Planning Commission - Item #9 (1/14/2016) - SL OCOG Monument Sign

Planning Commissioners,

Proposed Entry Sign at Highland and Highway 1 (with 6' tall figure)

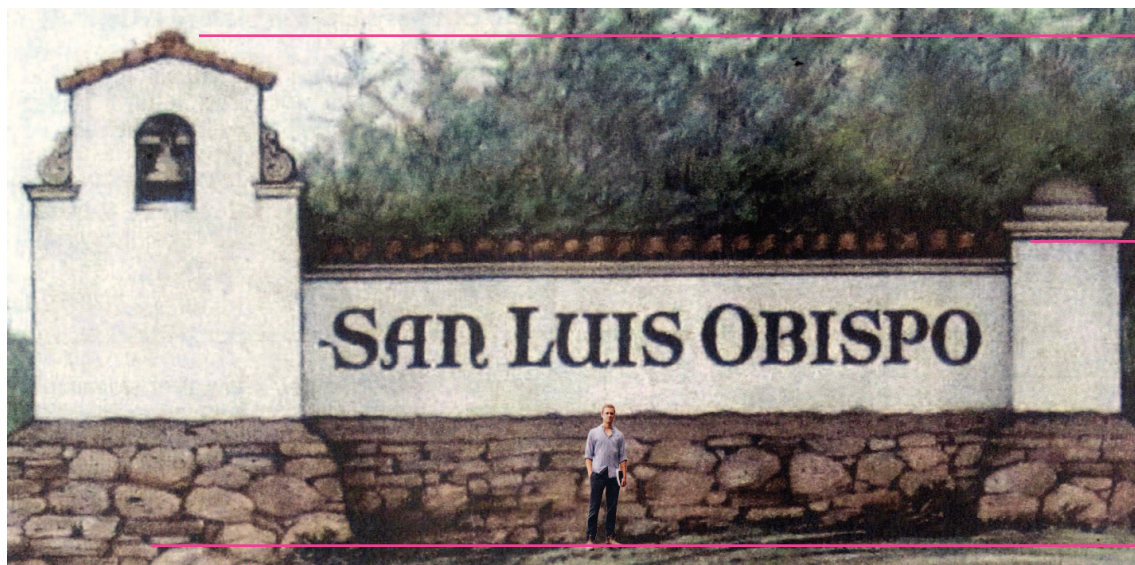
I believe your direction to the applicant seemed more than reasonable. I recall that Commissioner Meyer suggested a size reduction of the monument sign to 75% of the proposal. However, I would suggest that 75% is extremely generous. I would think that the sign could easily be reduced to 50% of its height, and perhaps no more than 75% of its width, and still be more than adequate to serve its intended function.
